THE PADDINGTON SOCIETY Inc.
For Community and Heritage
Est 1964

Director
Strategic Assessment
Department of Planning
GPO Box 39
Sydney NSW

Scottish Hospital Redevelopment - MP10_0016 Part 3A 2 Cooper Street Paddington

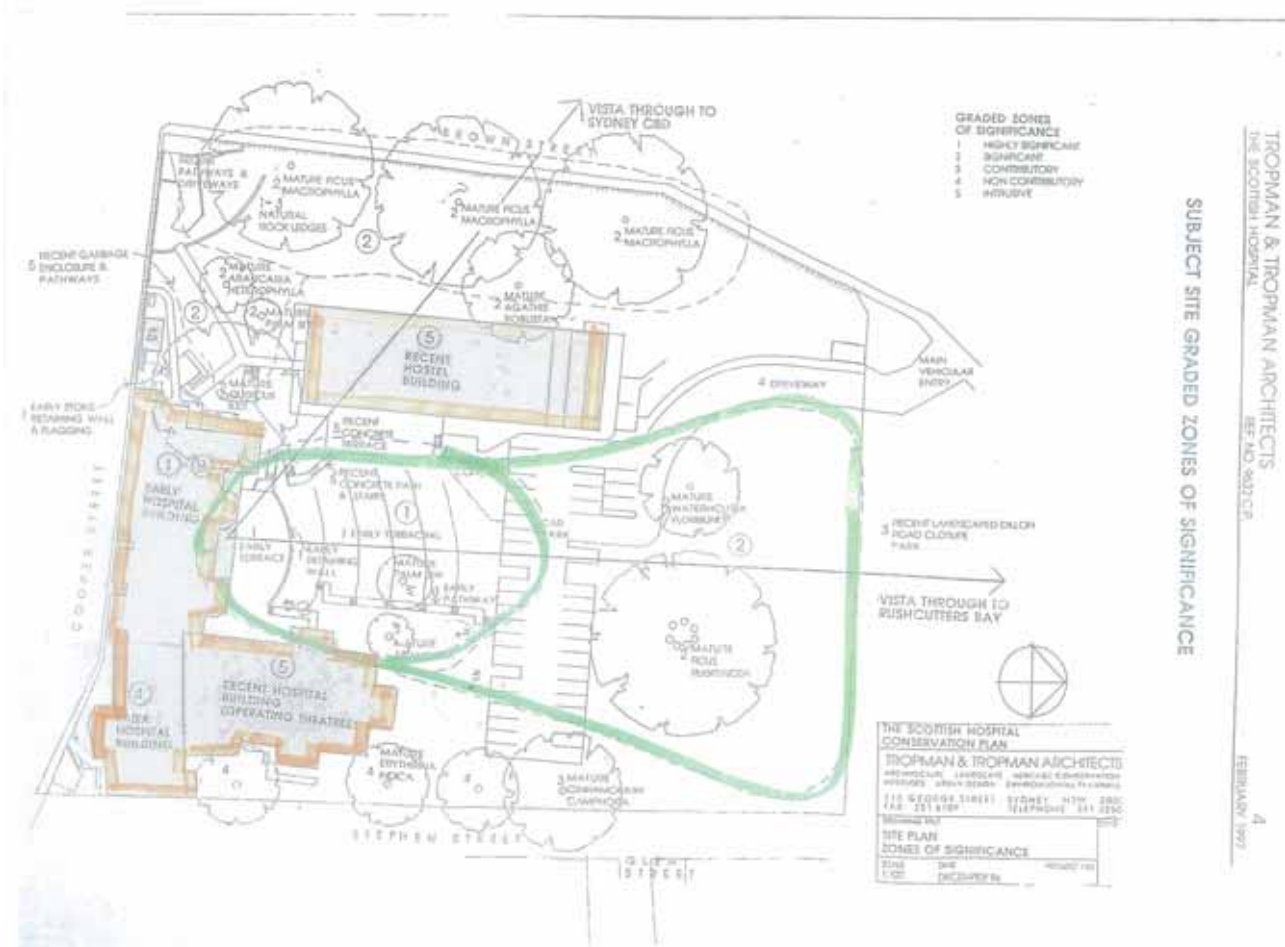
Existing inappropriate height as exhibited at 40 Stephen Street should not be used as justification for height on the site. The new rules were specifically created to prevent such things again in Paddington.

The proposed fracturing and stepping of form designed to “minimise” the impact of height creates an inappropriate architectural response. This is particularly apparent when nearly 90 trees are removed, exposing all this large development to public view.

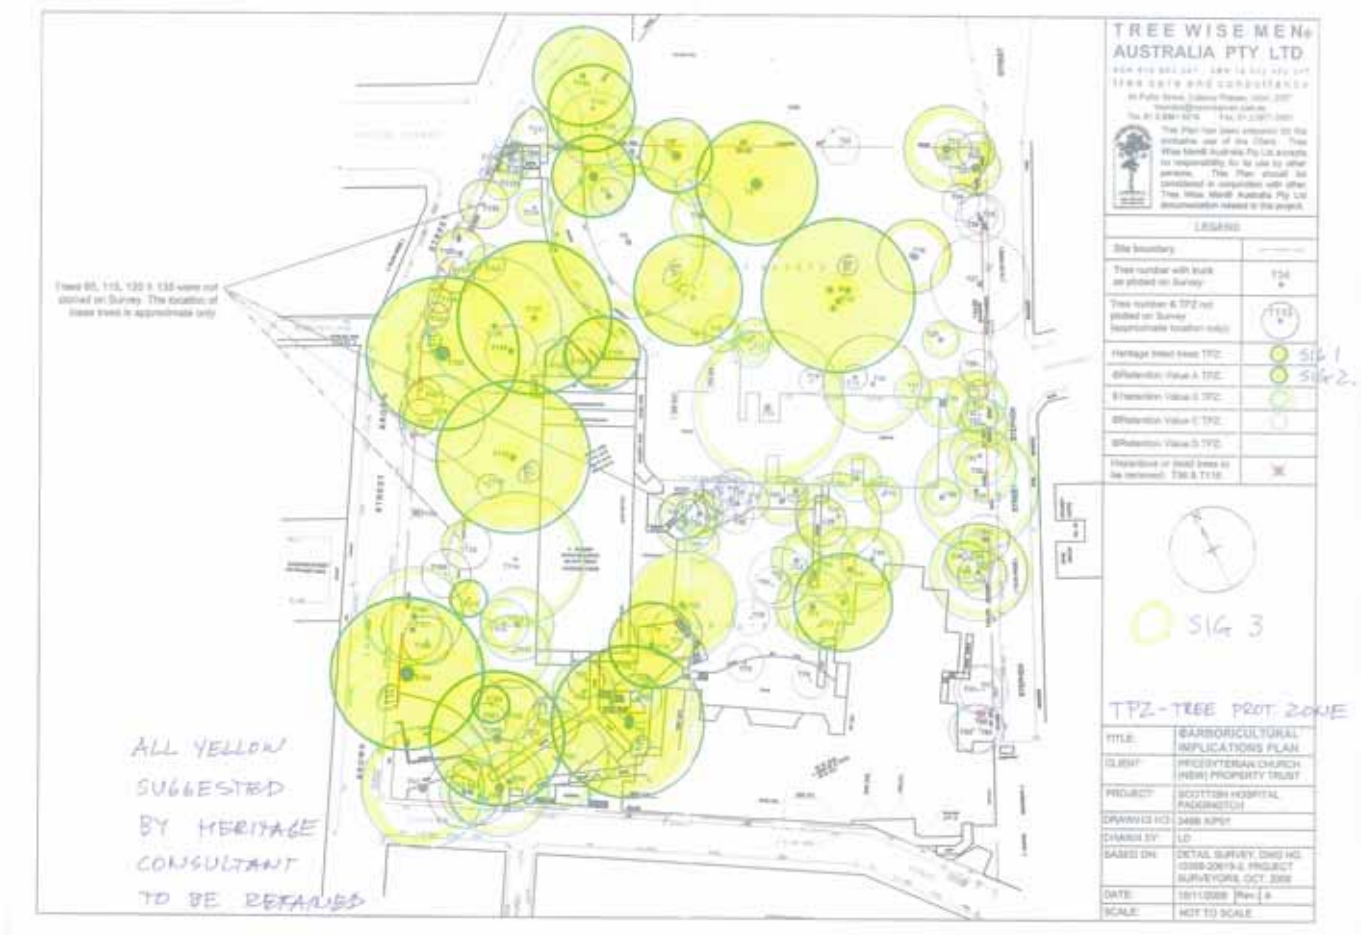
The arboricultural assessment "recommends" the removal of over 70 trees simply because they are within "construction zones". This is no reason for removal. The trees should be retained. Most would be normally protected by Council tree protection controls. For example:

- T13 is 18m high, some 24m in diameter and in good condition (Retention Value B). It should be retained.
- T72 is a Hoop Pine, 20m high and in good condition (Retention Value A). It should be retained.
- T35 is 17m high, some 15m in diameter and in fair condition with good vigour (Retention

Value B). It should be retained.

- T37 is 19m high, some 20m in diameter and in fair condition with good vigour (Retention Value B). It should be retained.
- T43 is some 17 m high, some 15m in diameter and in fair condition with good vigour (Retention Value B). It should be retained.
- T112 is some 16m high, some 9m in diameter and in fair condition with fair vigour (Retention Value B). It should be retained.
- T114 is some 20m high, some 20m in diameter and in fair condition with good vigour (Retention Value B). It should be retained.

A large number of trees in good and fair condition are proposed for removal. A total of 35 trees with Retention Value B are to be removed. They should all be retained.

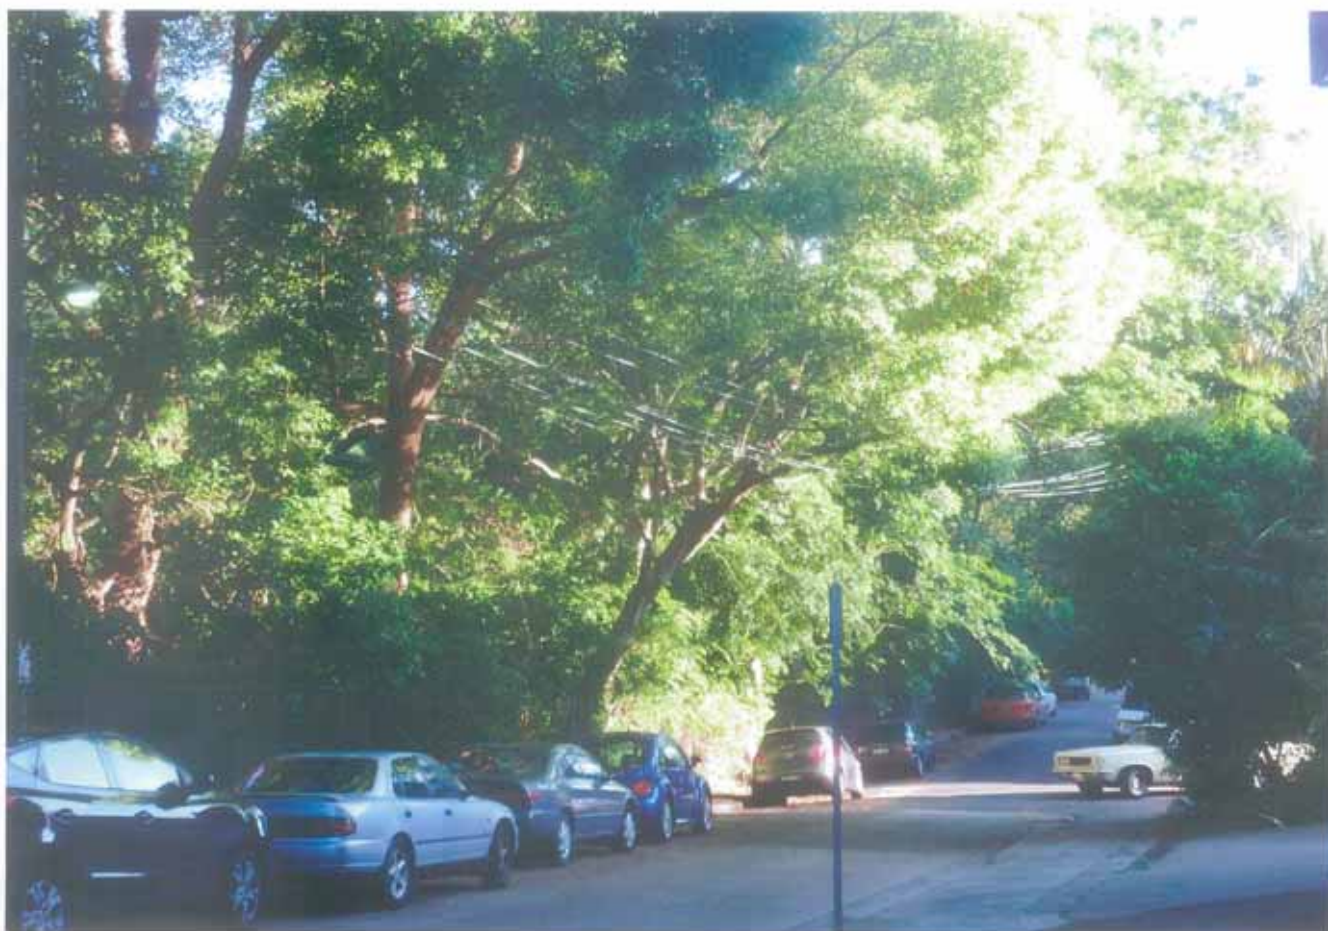
Excavation is perilously close to many trees proposed to be retained. Notwithstanding the “pruning analysis” for two of the trees T18 and T81 identified in the arborist report the basement excavation will require additional branch and root pruning for these and many other trees.

We also note that the dementia garden appears to be in the most important part of the original terraces and the upper terraces are “privatised” as private courtyards.

BUILDINGS OVERWHELM BROWN ST

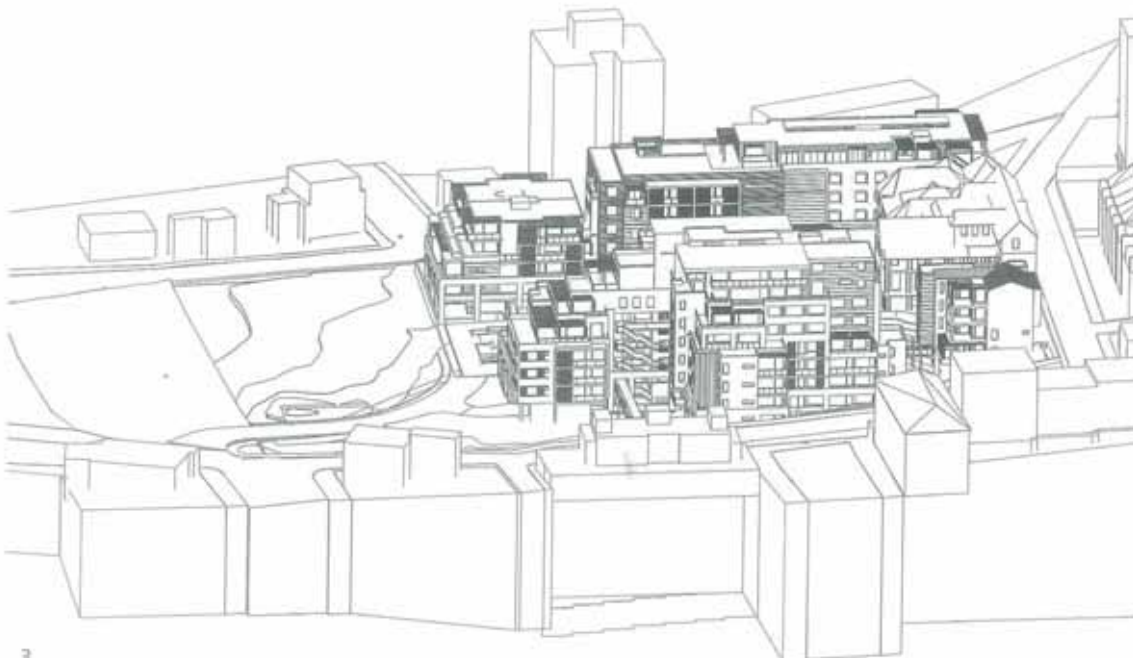
- The proposal does not comply with Seniors Living Policy-Urban Design Guidelines for infill development 2004 with regard to context, respect for heritage, built edges and impact on neighbours.
- The proposal does not comply with SEPP 65 or the RFDC with regard to scale, built form, density, landscape, amenity, affordability or aesthetics.
- The proposal does not comply in fact or spirit with the Woollahra LEP 1995.
- The proposal does not comply with the Paddington Heritage DCP.
- The proposal does not comply with Woollahra Council's Planning Principles for the site.
- The Paddington Society does not support the applicant's urban design study.
- The Brown Street ILU is too high at 9 floors near Brown Street and too close to Brown Street.

- The Stephen Street ILU is too high and too close to Stephen Street.

BUILDINGS OVERWHELM · STEPHEN ST.
· HERITAGE

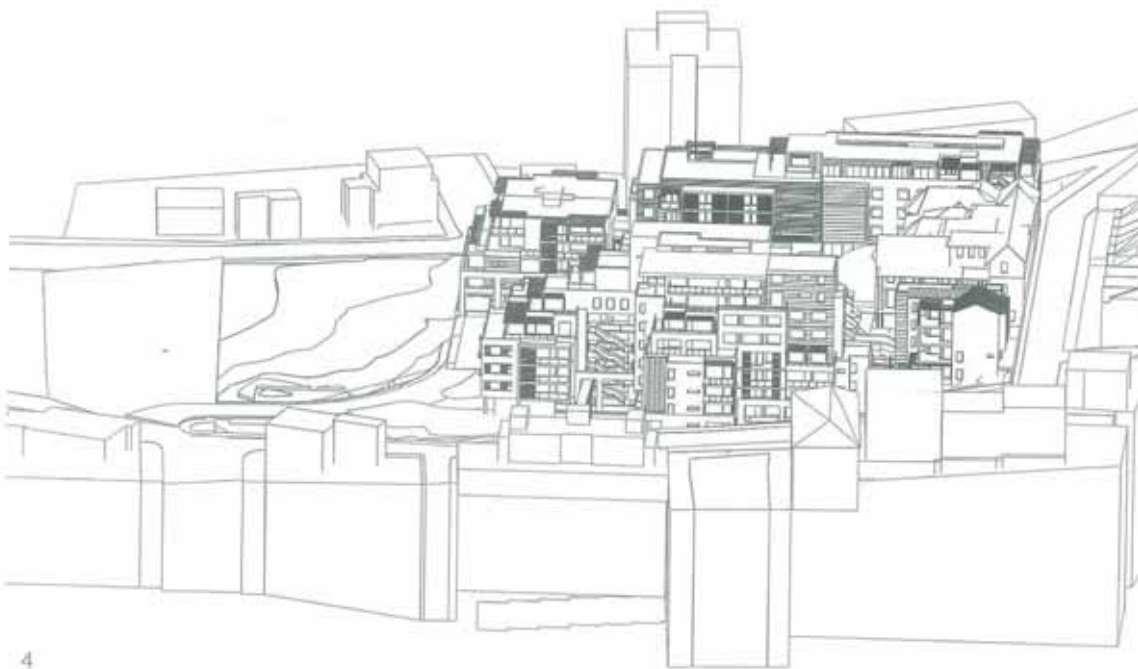
- The Stephen Street ILU intrudes into the Glen Street view corridor and should be deleted.
- The new buildings dominate the terraces.
- The architectural response is too fractured and too stepped in form, trying to mitigate unsuccessfully against its height and bulk.
- No construction should be permitted in the Brown Street gully
- The Conservation Management Plan fails to properly consider the heritage significance of the gardens and grounds. No landscape conservation management plan is provided.
- The Paddington Society opposes the demolition of the terraces.
- No heritage assessment of the trees has been provided.
- Consequently the urban design analysis carries no weight.

BUILDINGS OVERWHELM · GLEN VIEW ST.
· GLEN ST.

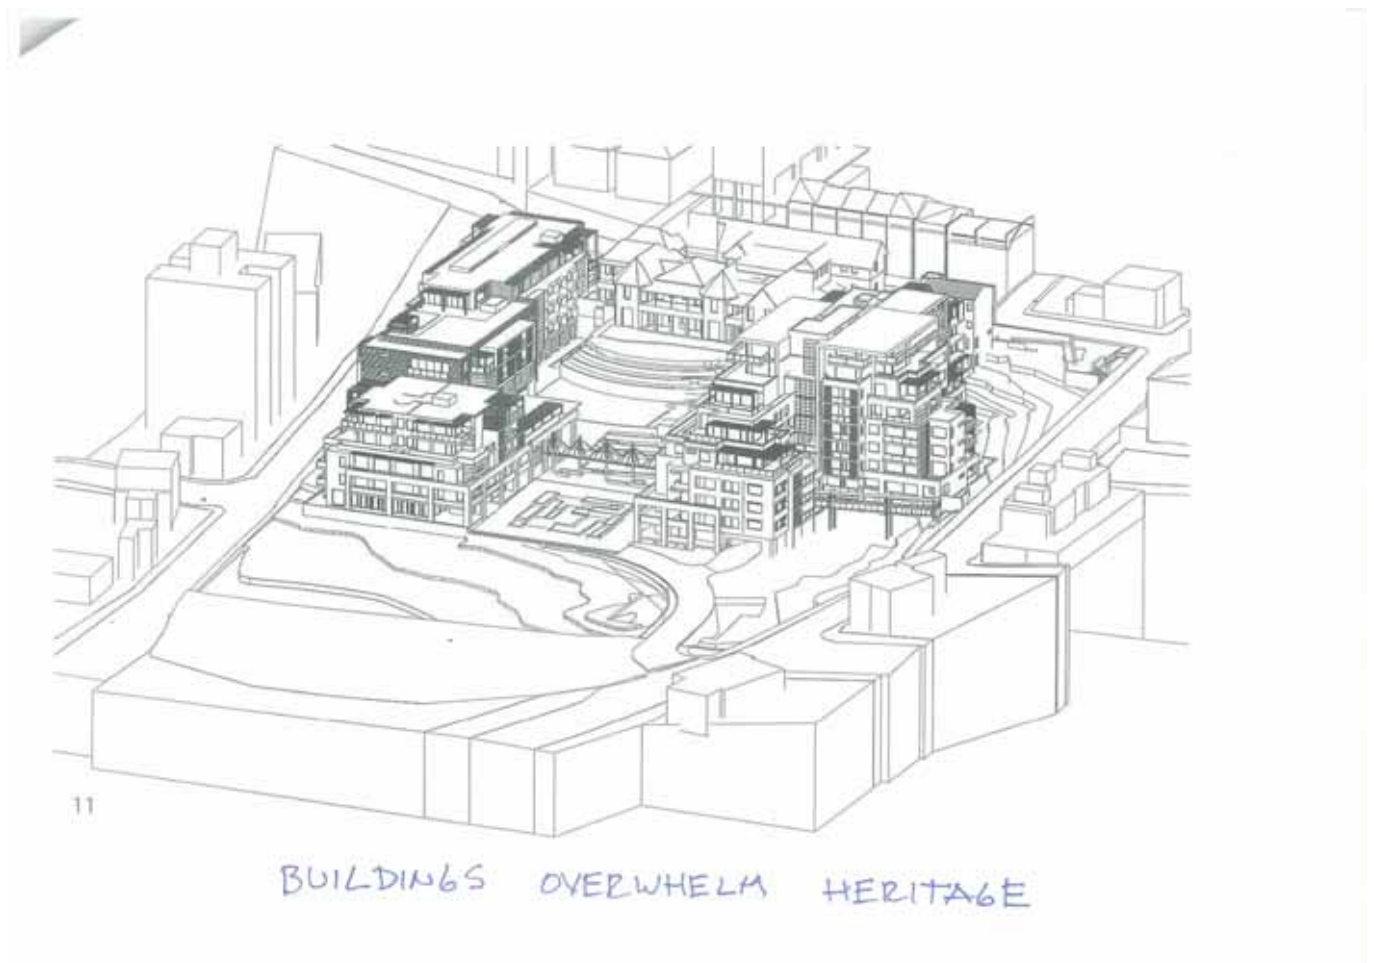
- No vehicular access should be permitted from Stephen Street.

- The nearest accessible bus stop is 290 metres from the site.
- The scale of development, the size of apartments, the number of cars, the size of excavation, the quantity of excavated material and the removal of approx 90 trees is not in accordance with sustainability principles.
- No assessment of the impact of hydrogeological on trees has been provided
